DOCUMENT NUMBER:	TITLE:	
FM-000-0004-48	Form - Product Change Notice	AZENTA LIFE SCIENCES
REVISION: H	DOCUMENT CLASSIFICATION:	
DCO# DCO005391	04-Forms, Templates or Other

PCN Number: PCN48801311-0003 Revision: A Creation Date: 04 Mar 2025

Description and Reason for Change:

Part Number	Item Description
48-8013-11	ASSY,CARTRIDGE,INTELLIXCAP,96,MATRIX,INT
	△ AZENTA

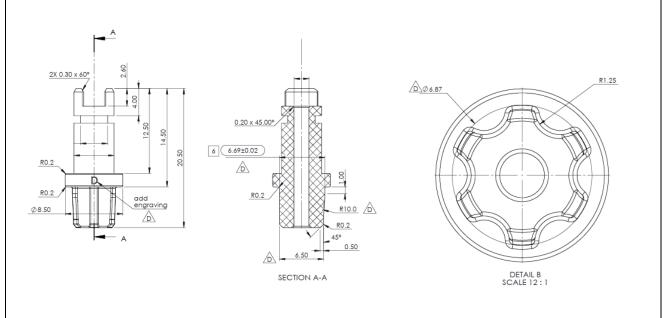
The new cap driver has been designed to improve engagement with the caps. Please see below, for information only, the new design of the affected part, with the new dimensions and geometry:
